Tilden Middle School/Rock Terrace School, Mandatory Referral, MR2017014

Completed: 10-30-17

RECOMMENDATION

Figure 2: Proposed Site Plan

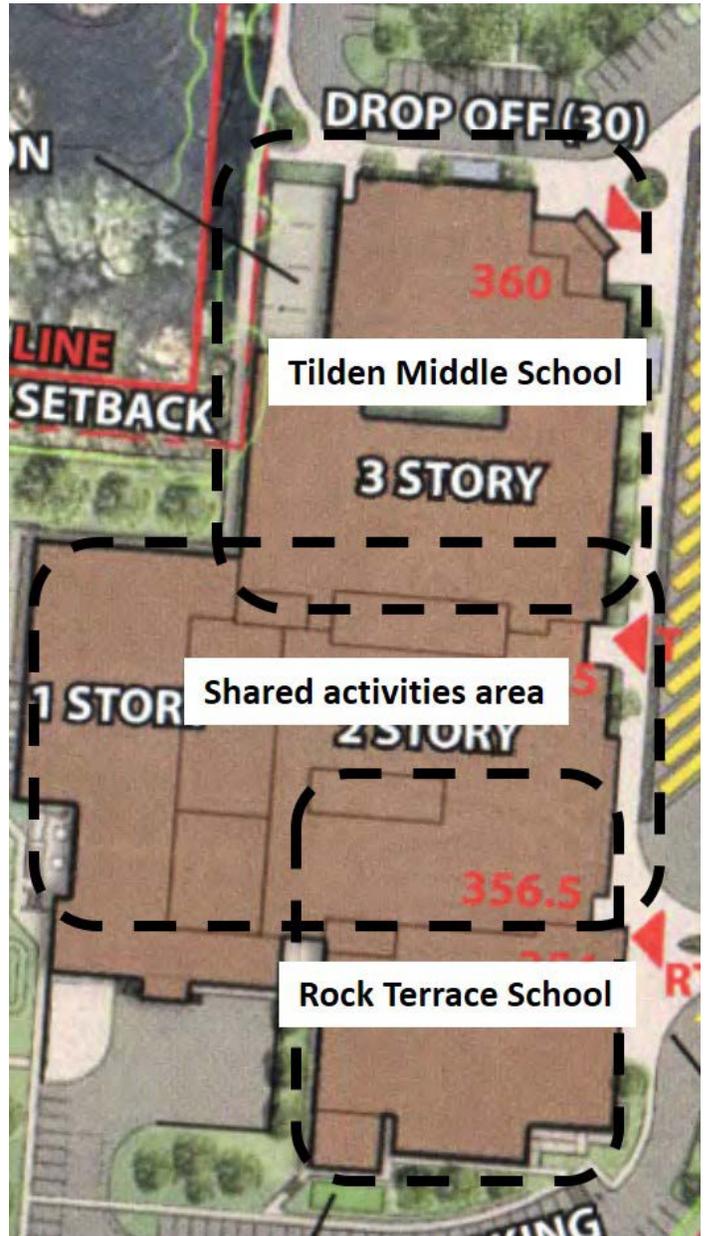
6. Maintain 5' of open space on both Tilden Lane and Marcliff Road to accommodate the ultimate right-of-way.
7. Redesign internal crosswalks to be ADA-compliant with handicap ramps within the northern parking area.

8. Crosswalks and ramps at the corner of the Tilden/Marcliff intersection must be ADA compliant.

OVRALL SITE PLAN

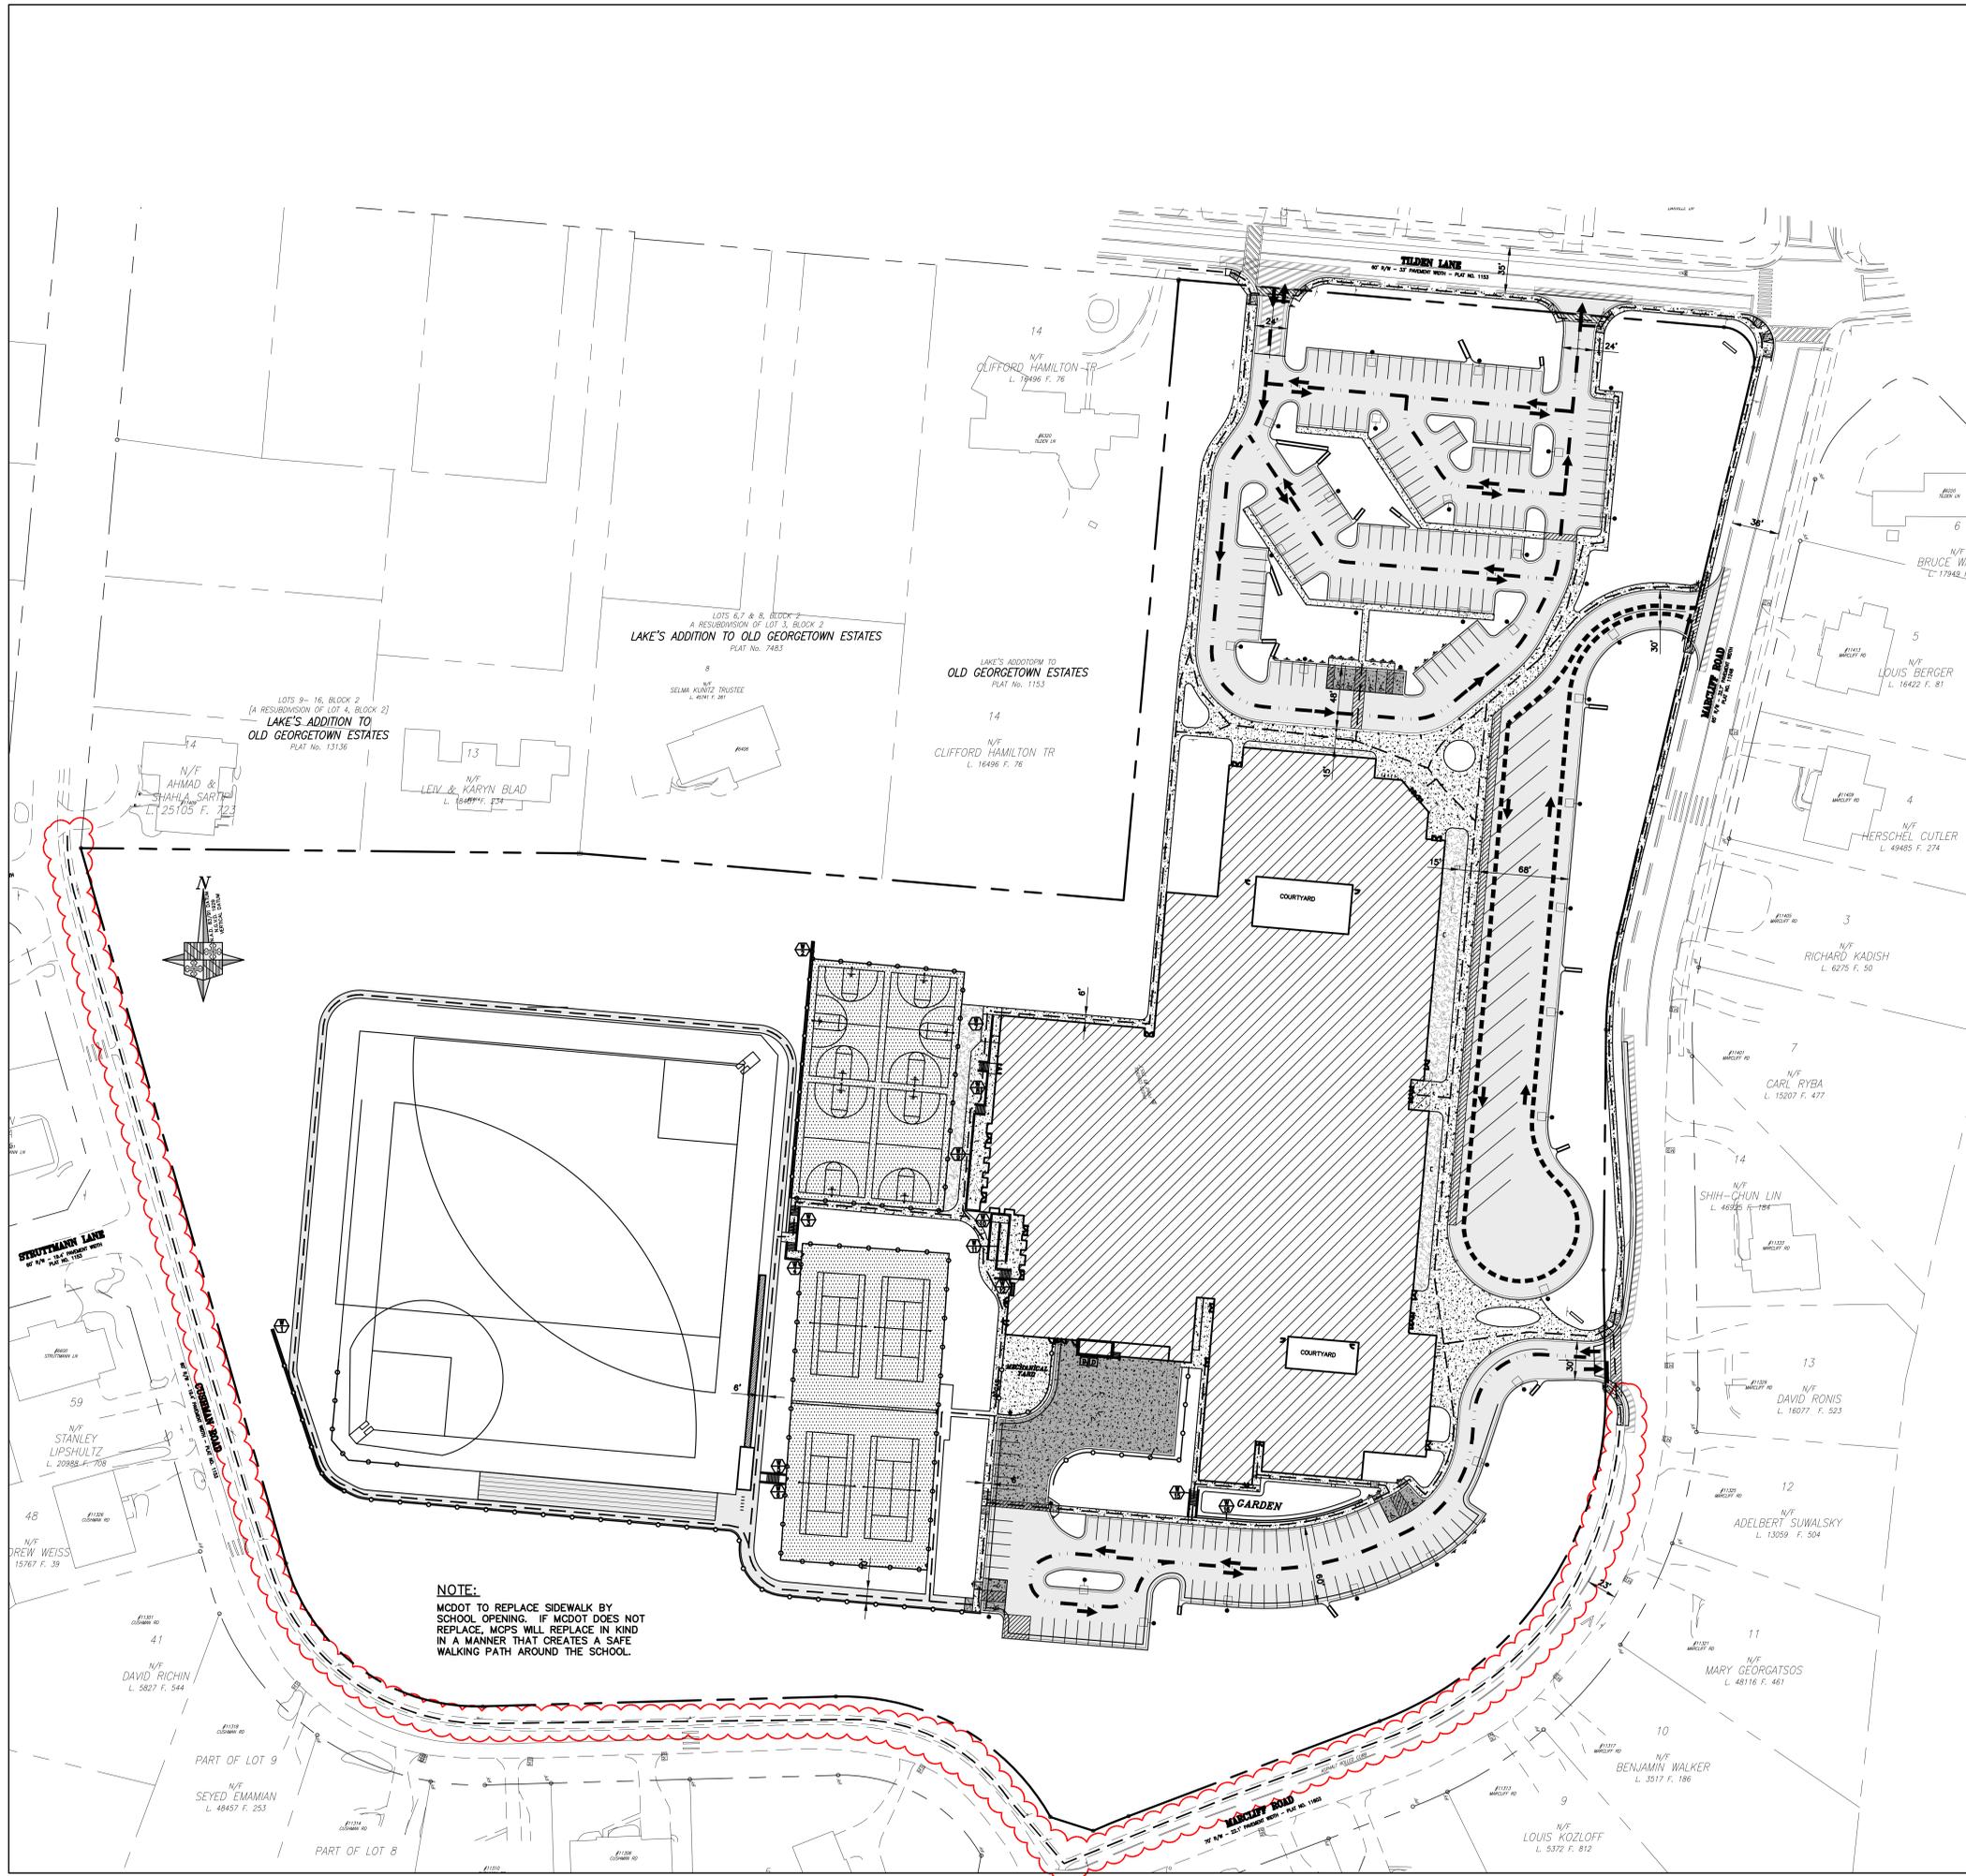
MCPS has been working with MCDOT on the pedestrian improvements along Marcliff Road and Cushman Road. Revising the current open section roadways will require significant site improvements, including addressing storm drain adequacy and alignment. If MCDOT is not able to replace these sidewalks by the time the new school facilities open, then MCPS will replace the facilities with a similar level of pedestrian facility to the existing sidewalk.

NOTE:
 MCDOT TO REPLACE SIDEWALK BY SCHOOL OPENING. IF MCDOT DOES NOT REPLACE, MCP'S WILL REPLACE IN KIND IN A MANNER THAT CREATES A SAFE WALKING PATH AROUND THE SCHOOL.
